To: T10 Committee (SCSI)

From: George Penokie (IBM/Tivoli)

Subject: SAS 1.1 - Transport layer retry and argument passing fixes

Figure 149 — ST\_I (transport layer for SSP initiator ports) state machines

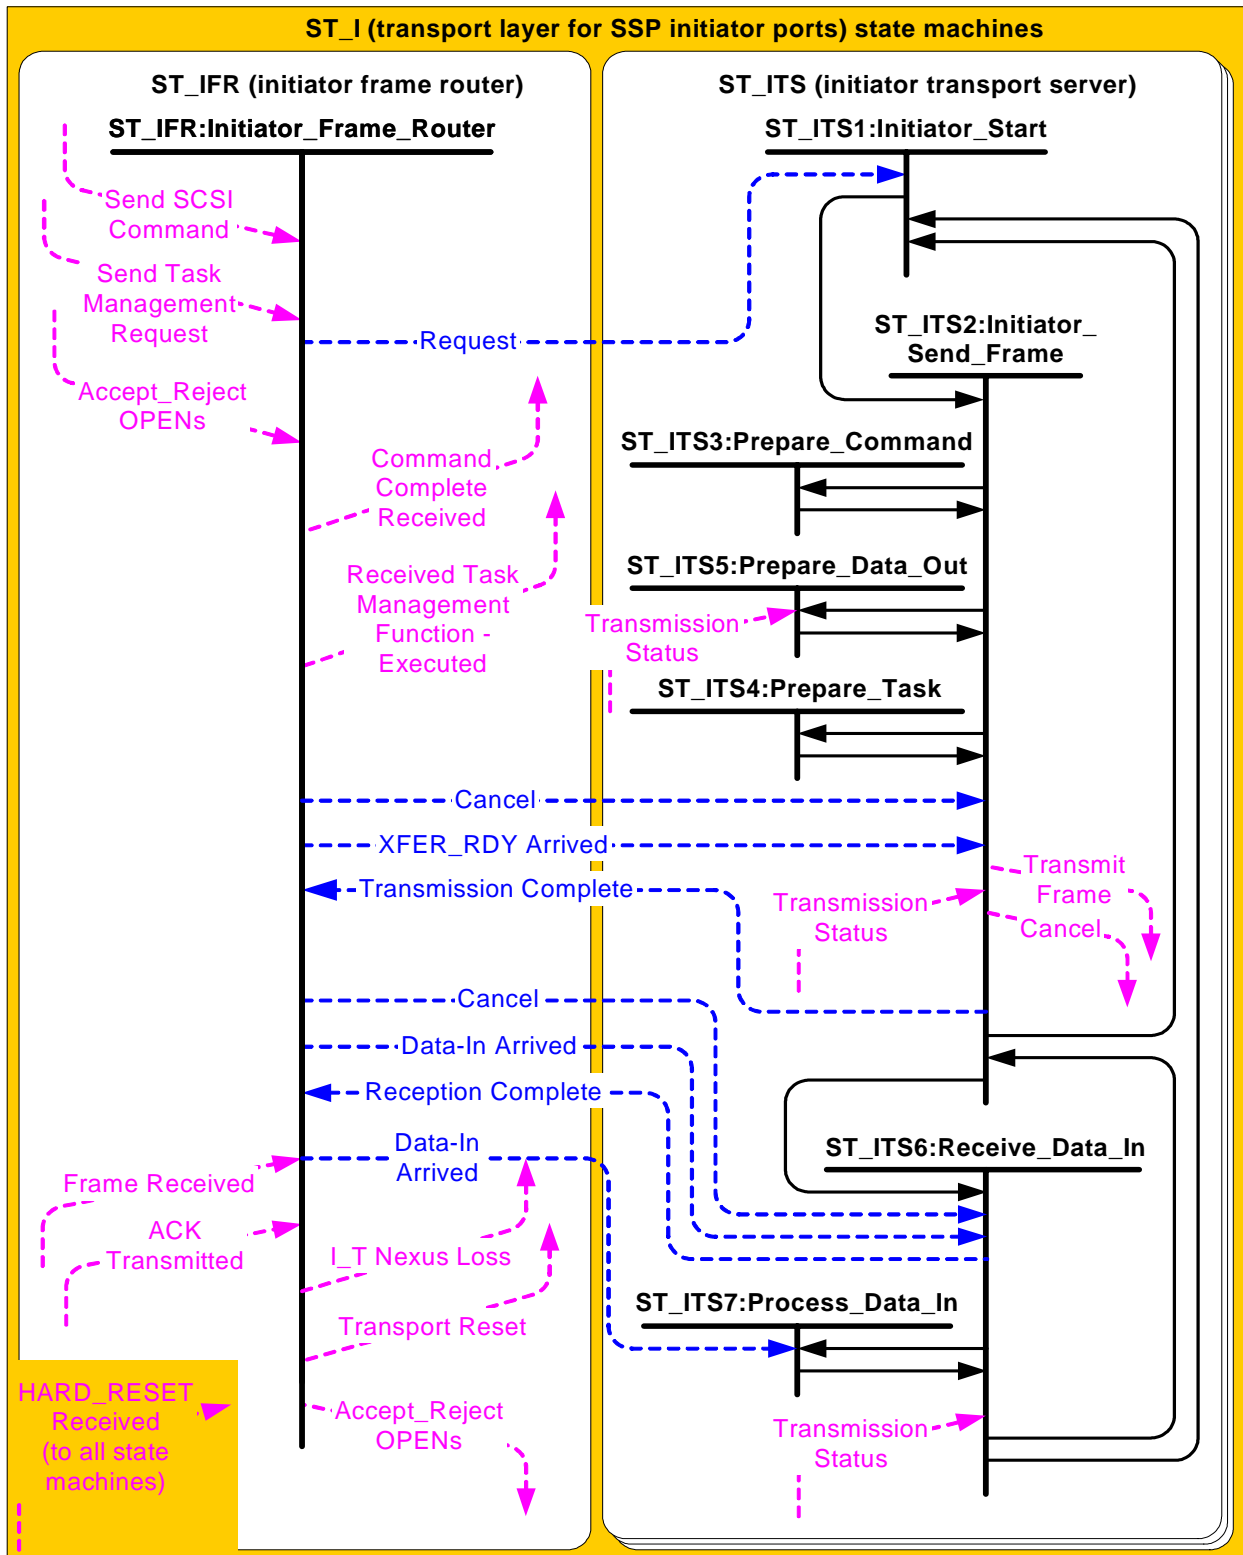
Editor's Note 14: Added Data-In Arrived message into ST\_ITS7 and Transmission Status

[confirmation into ST\\_ITS5 to allow for non-interlocked DATA frame transfers.](#)

Figure 150 — ST\_T (transport layer for SSP target ports) state machines

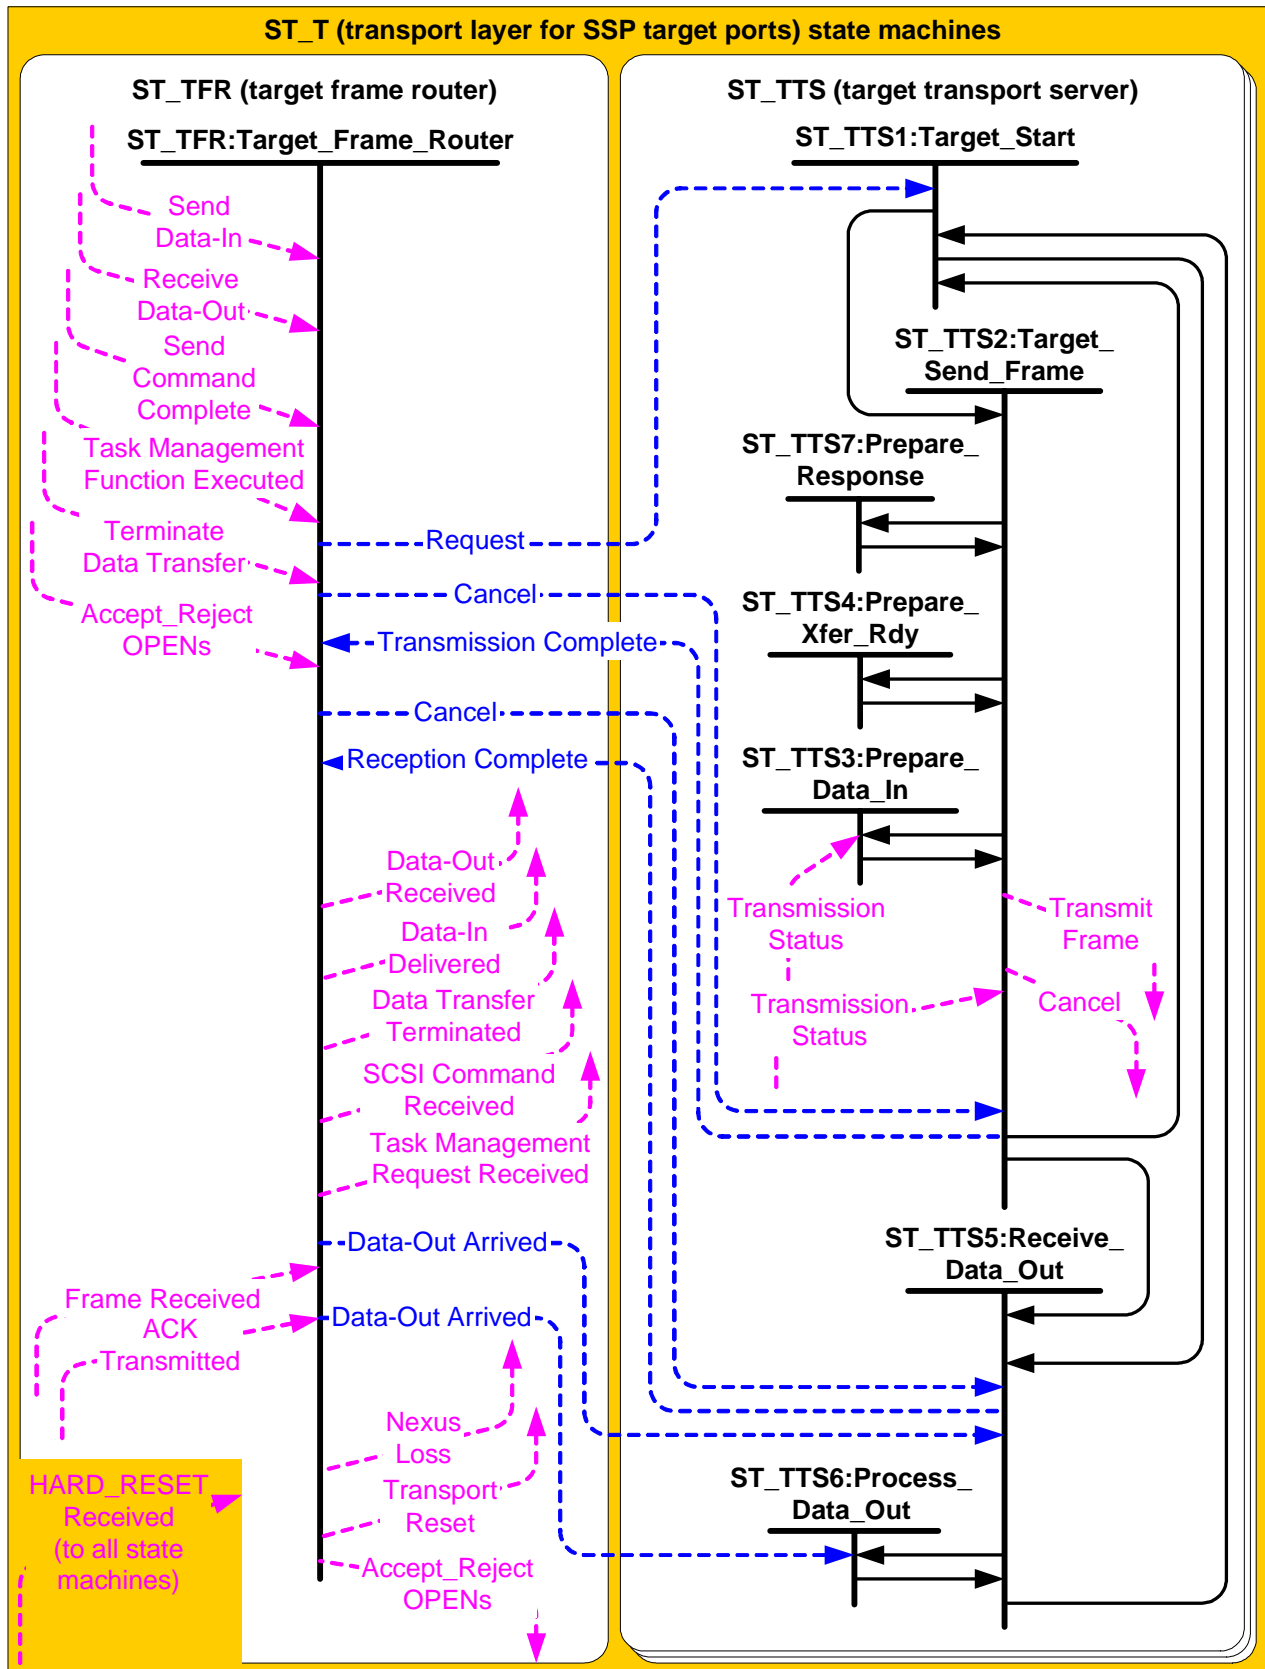
[Editor's Note 15: Added Data-Out Arrived message into ST\\_TTS6 and Transmission Status confirmation into ST\\_TTS3 to allow for non-interlocked DATA frame transfers. Also removed the ST\\_TTS5 to ST\\_TTS2 transition which was not defined in SAS 1.1. rev 9 and is not needed.](#)

Figure 151 — ST\_I (transport layer for SSP initiator ports) state machines

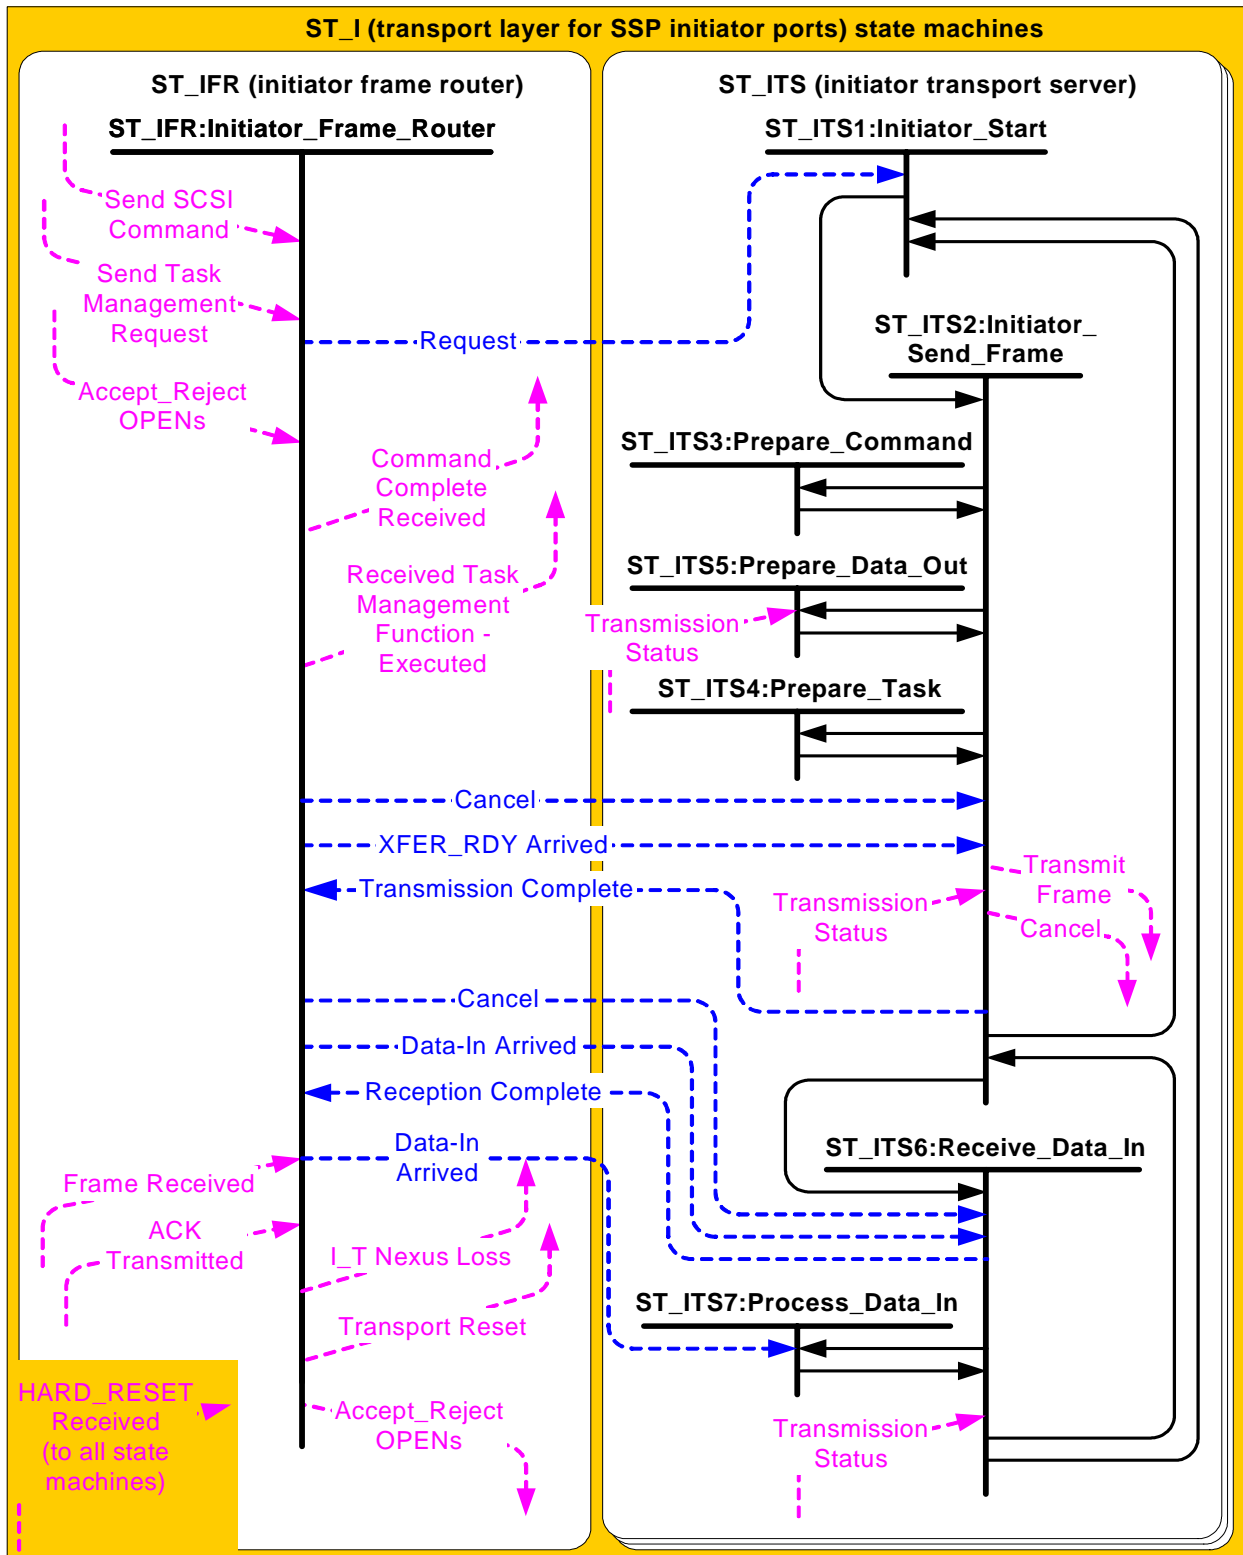
Editor's Note 16: Added Data-In Arrived message into ST\_ITS7 and Transmission Status

Figure 152 — ST\_T (transport layer for SSP target ports) state machines

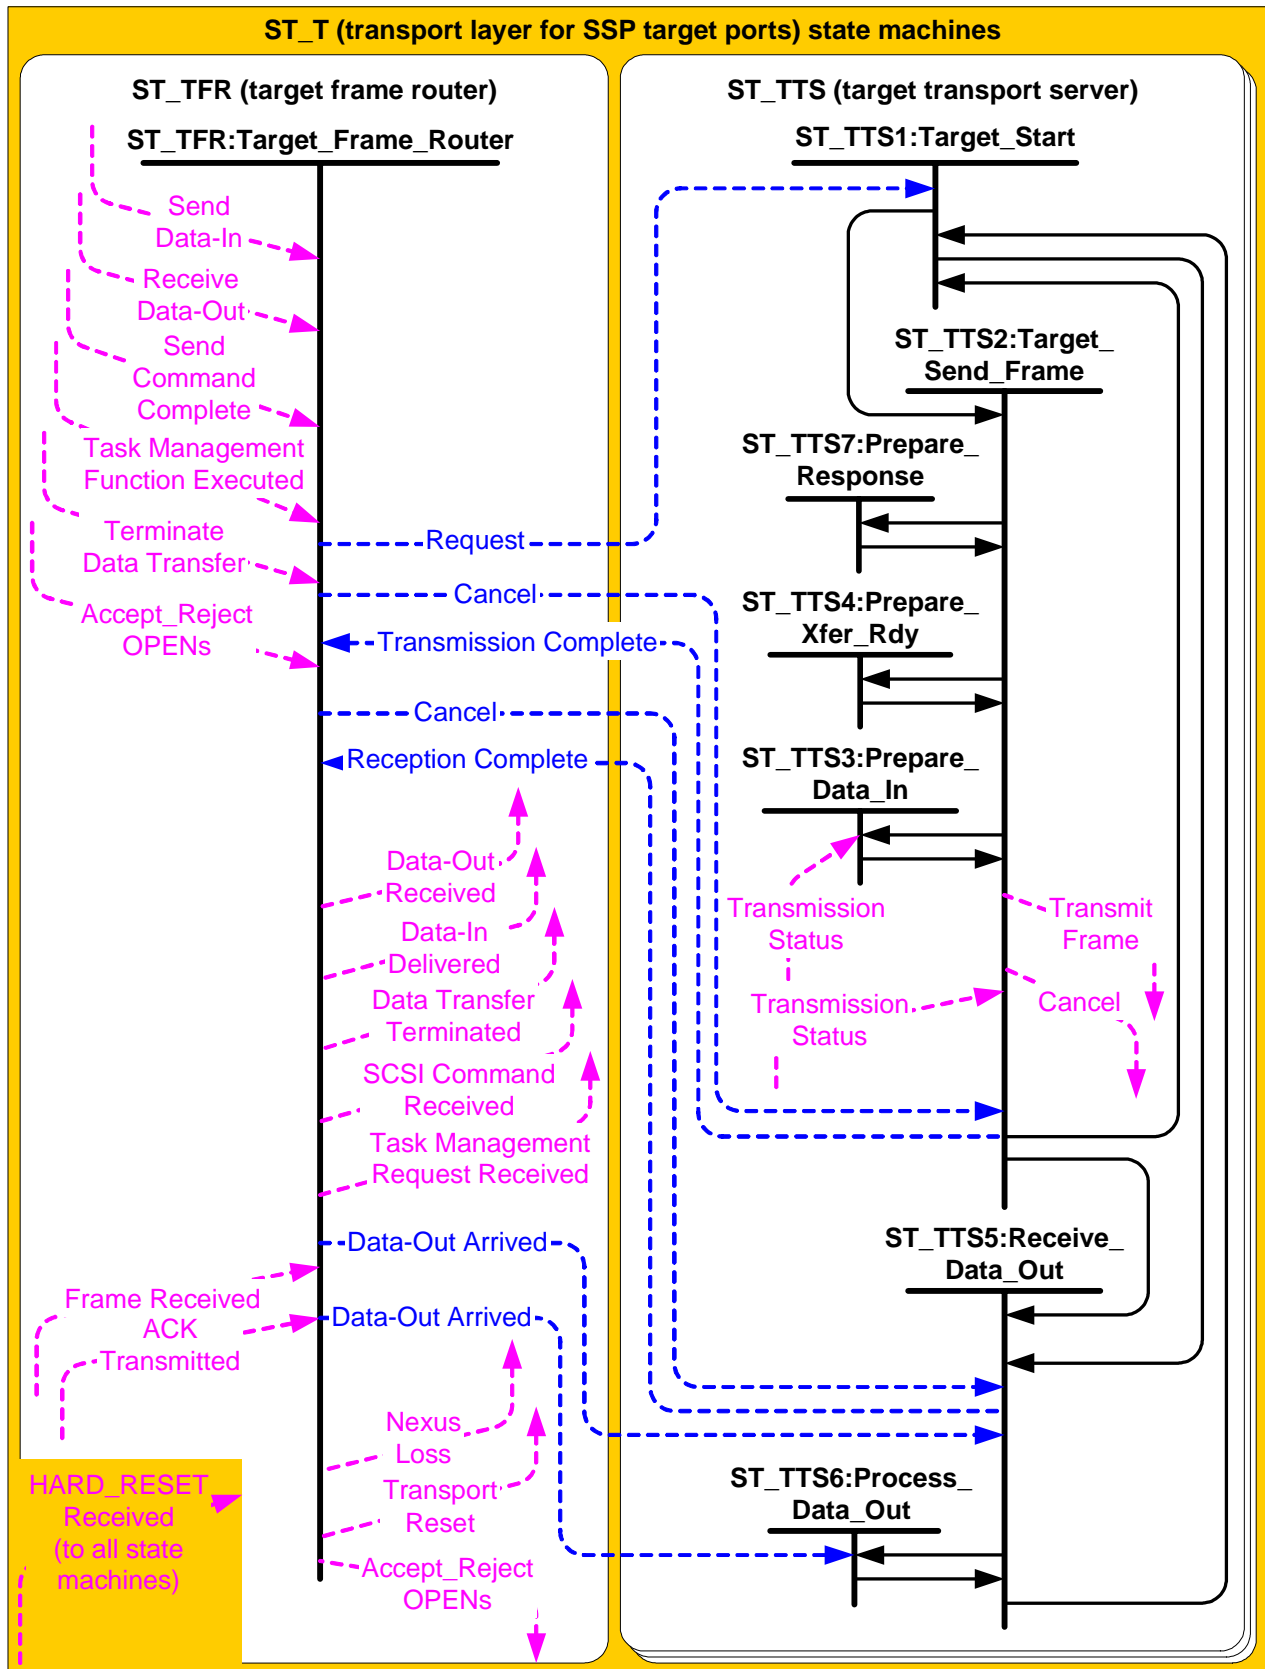
Editor's Note 17: Added Data-Out Arrived message into ST\_TTS6 and Transmission Status confirmation into ST\_TTS3 to allow for non-interlocked DATA frame transfers. Also removed the ST\_TTS5 to ST\_TTS2 transition which was not defined in SAS 1.1. rev 9 and is not needed.
